APPENDIX E

Liberty Response To Mountain View Fire (NOV)

CPUC-ID: E20201117-01
Regarding: Notice of Violation
Location: Mountain View Fire, Coleville, California

Annotated Demonstration of Measured Radial and Calculated Horizontal and Vertical Conductor Clearances

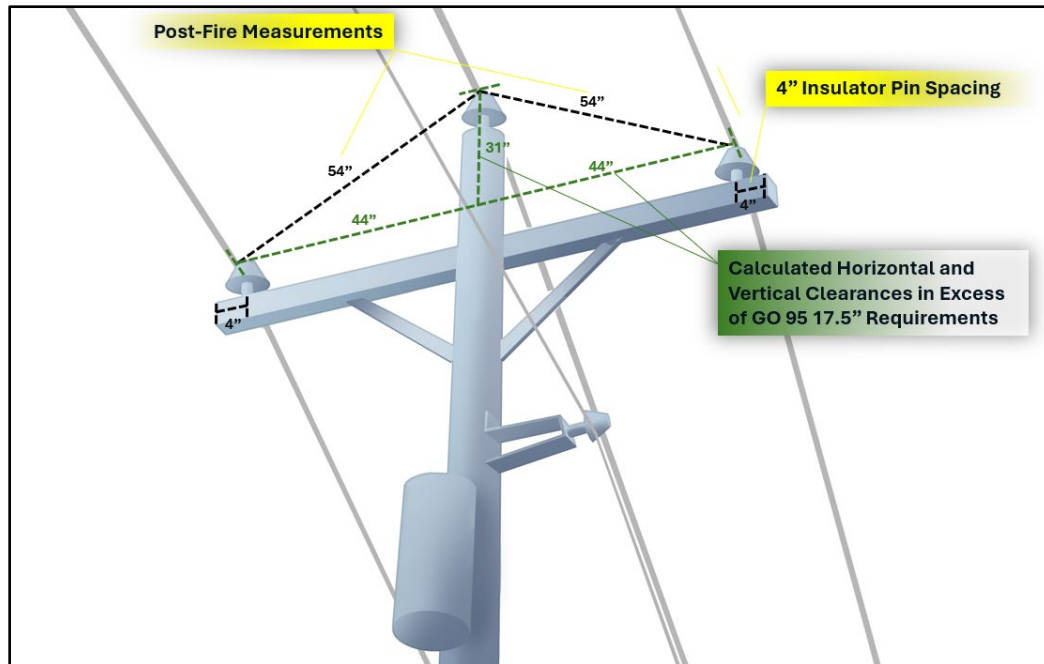
The Subject Facilities satisfied GO 95’s specific clearance requirements and incorporated additional measures accounting for known local conditions. GO 95, Rule 38 and Table 2 specifically address conductor separation and the effect of wind on required clearances. The NOV further identifies Table 2, Footnote (zz), which provides that in high-wind areas a utility “may need to take extra measures to maintain all required separations” and identifies spacer bars and increased pin spacing as nonexclusive examples of such measures. The configuration of the Subject Facilities exceeded the minimum clearance requirements of GO 95. Moreover, consistent with Rule 31.1 and Table 2, Footnote (zz), Liberty had in place and pursued additional measures to account for the known local conditions affecting the Topaz 1261 Circuit. Those measures included increased conductor separation substantially exceeding GO 95’s minimum requirements and an active, Commission-approved project to further harden the circuit.

The existing configuration of the Topaz 1261 Circuit provided enhanced conductor separation. Liberty purchased its utility system from Sierra Pacific, which had constructed the Topaz 1261 Circuit using a triangular crossarm configuration, with increased pin spacing at either end of an 8-foot crossarm and an elevated center phase to provide enhanced clearances between the conductors and mitigate the risk of contact.

This arrangement provided clearances that far exceeded GO 95’s conductor clearance requirements specified in Rule 38 and Table 2. For this type of construction on distribution facilities, GO 95 mandates a minimum horizontal separation of 17.5 inches between conductors, with the elevated center phase having a vertical separation at least equal to the pin spacing for the voltage class (i.e., 17.5 inches). Measurements recorded shortly after the Mountain View Fire identified radial clearances of 54 inches between the center phase and each of the road and field phases at Pole 266731. Based on these dimensions and configuration, 44 inches of horizontal clearance and 31 inches of vertical clearance were present on the Topaz 1261 Circuit. Thus, the Topaz 1261 Circuit incorporated the specific type of “extra measures” contemplated by GO 95, Table 2, Footnote (zz) for addressing known local conditions in high-wind areas—increased pin spacing beyond GO 95’s minimum requirements.¹

Post-Fire Conductor Radial Clearance Measurements at Pole 266731²

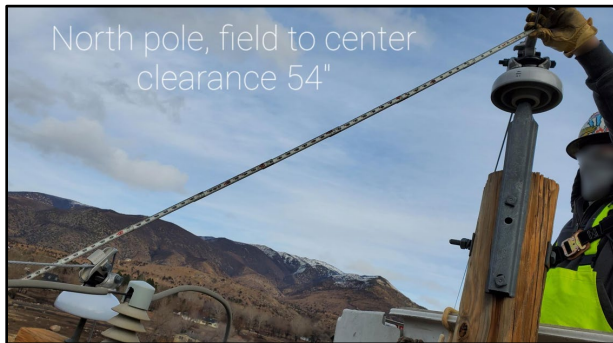
² Distance of 54 inches between the center and road phase conductors (left photograph) and between center and field phase conductors (right photograph).
